**RE: RFP FOR GEOTECHNICAL ENGINEERING FOR WATER DEPARTMENT REPLACEMENT
OF CULVERT STRUCTURES 1 AND 2 - ADDENDUM NO. 1 - RFP GENERAL REVISIONS**

RFP GENERAL REVISIONS

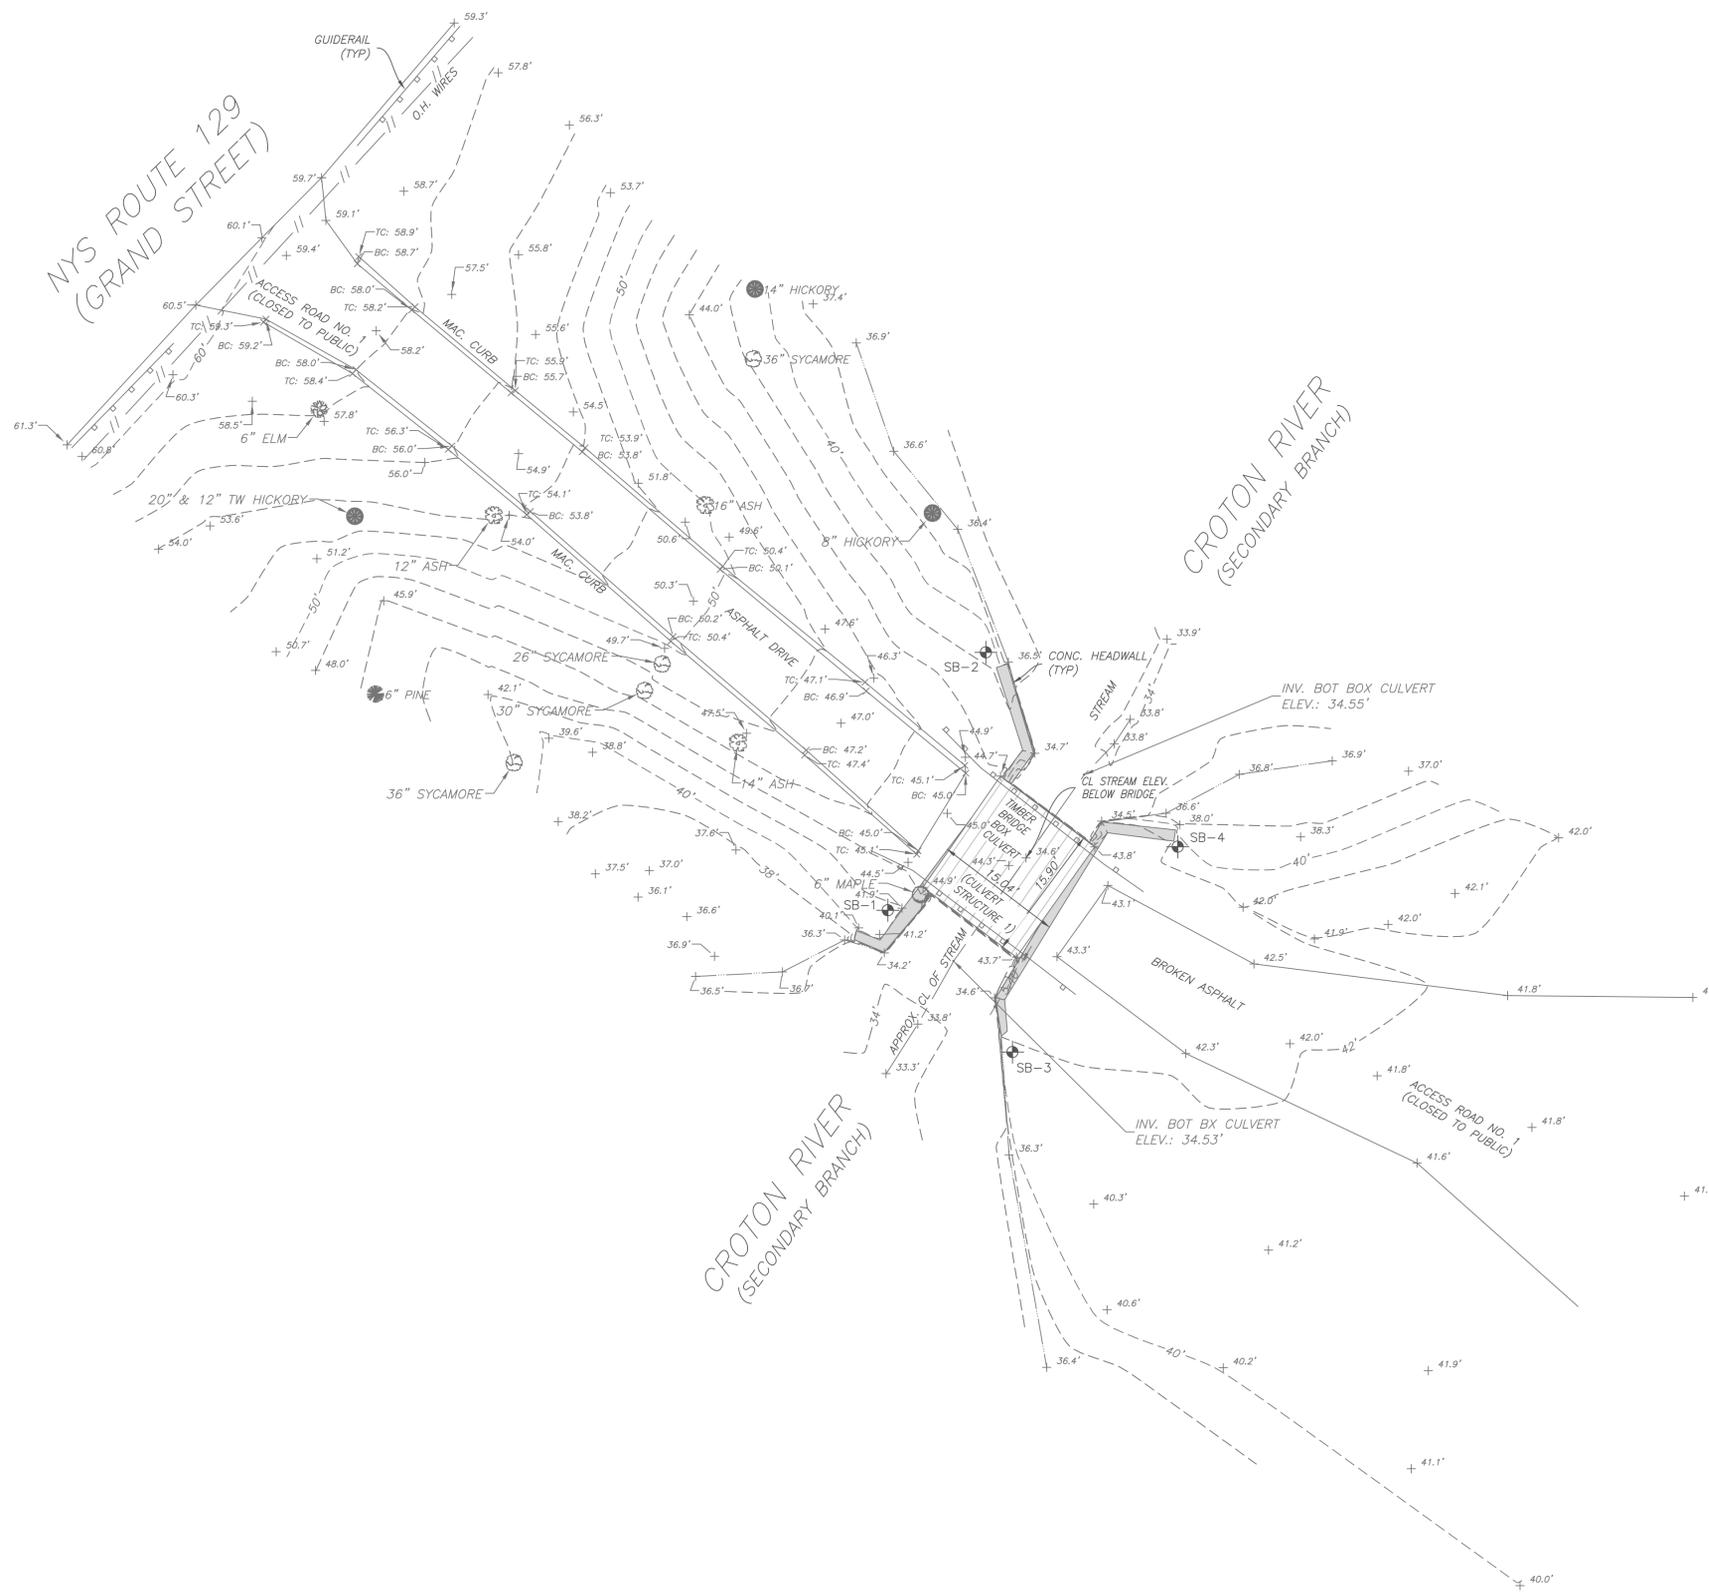
“...four (4) proposed test borings with continuous split spoons samples collected at two (2) foot intervals, with two (2) borings extending approximately twenty-five (25) linear feet (LF) and two (2) borings extending approximately thirty-five (35) LF below grade.”
3. Proposers shall note that the four (4) proposed testing boring locations shall be generally located as illustrated on RFP Supplemental Drawings BLP-1 and BLP-2 “Test Boring Location Plan”, last revised March 16, 2015. Prior to the start of work, final test boring locations will be field verified with the Commissioner of Public Works and other Village Staff.

REVISION BLOCK			
REVISION NUMBER	DATE	APP'D BY	REVISION
1.	03/16/2015	ARC, PE	REVISED TEST BORING LOCATIONS AND DEPTHS
0.	03/06/2015	ARC, PE	ISSUED FOR SUBSURFACE INVESTIGATION RFP

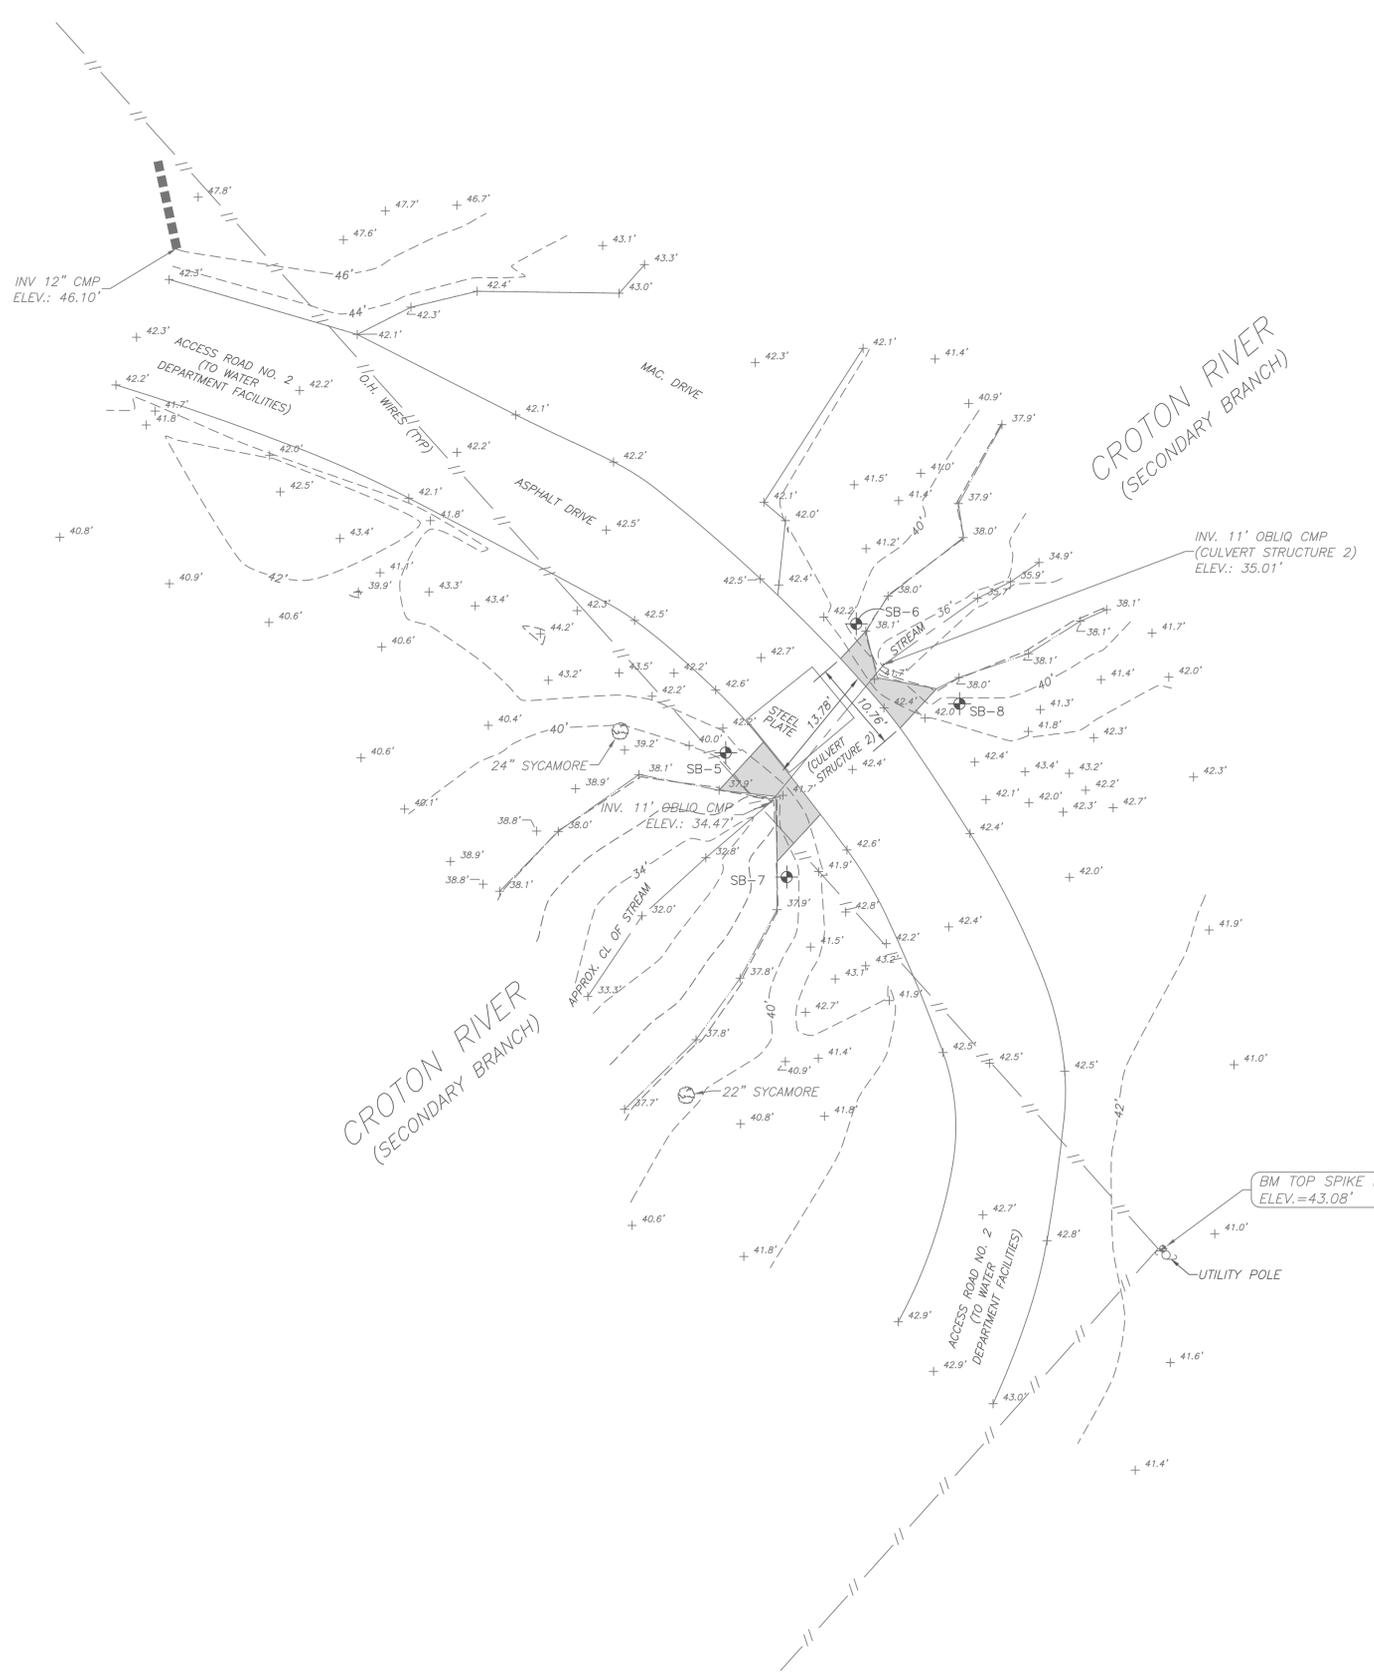
REVISION BLOCK			
REVISION NUMBER	DATE	APP'D BY	REVISION
1.	03/16/2015	ARC, PE	REVISED TEST BORING LOCATIONS AND DEPTHS
0.	03/06/2015	ARC, PE	ISSUED FOR SUBSURFACE INVESTIGATION RFP
